## Variants difference declaration

We, Harman Automotive Electronic Systems (Suzhou) Co., Ltd. hereby declares that between H097 and H087, the difference is described as below content, other parts are identical.

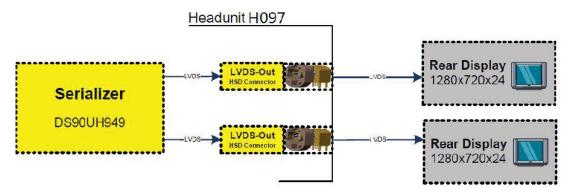
- In the H097, the LVDS serializer and the HSD connectors are assembled.
- In the H087, the LVDS serializer and the HSD connectors are <u>not</u> assembled.

Yellow parts are not assembled in the production of H087
